PLAT COMMITTEE

Case Number: 2025-PLT-018
Property Address: 305, 405 and 429 Fintail Drive (*approximate addresses*)
Location: Warren Township, Council District #20
Petitioner: Michael J. Jones, by Nathan Winslow
Zoning: I-3
Request: Approval of a Subdivision Plat to be known as Replat of Lot 2, Block A, and Block B, Replat of Thunderbird Commerce Center, dividing 109.99 acres into two lots and two blocks.
Waiver Requested: None
Current Land Use: Industrial / Undeveloped
Staff Reviewer: Michael Weigel, Senior Planner

2025PLT016 ; Preliminary Plat

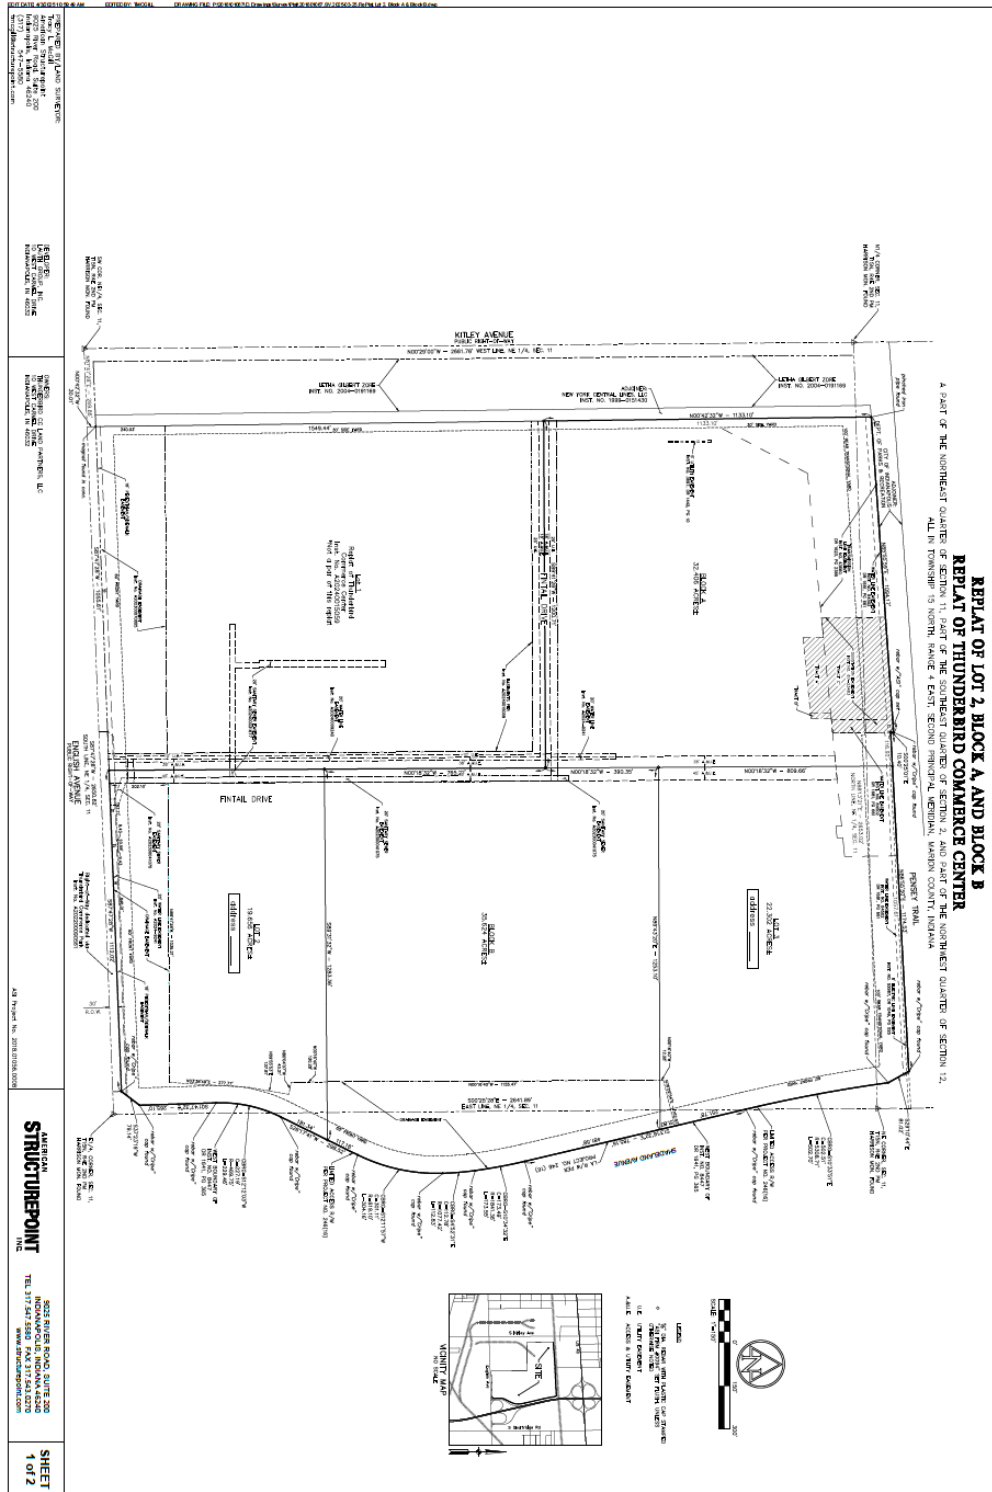
Staff recommends that the Plat Committee **approve** and find that the plat, file-dated April 3, 2025, complies with the standards of the Subdivision regulations, subject to the following conditions:

1. That the applicant provides a bond, as required by Section 741-210, of the Consolidated Zoning and Subdivision Ordinance.
2. Subject to the Standards and Specifications of Citizens Energy Group, Sanitation Section.

The entire site is accessed from English Avenue, from the south. Proposed Lot 2 would front English Avenue and be 19.656 acres in size, while proposed Block A and Block B would be accessed from a private drive and would be 32.406 and 35.624 acres respectively. The proposed plat generally meets the standards of the I-3 zoning classification, development standards, and variance commitments.
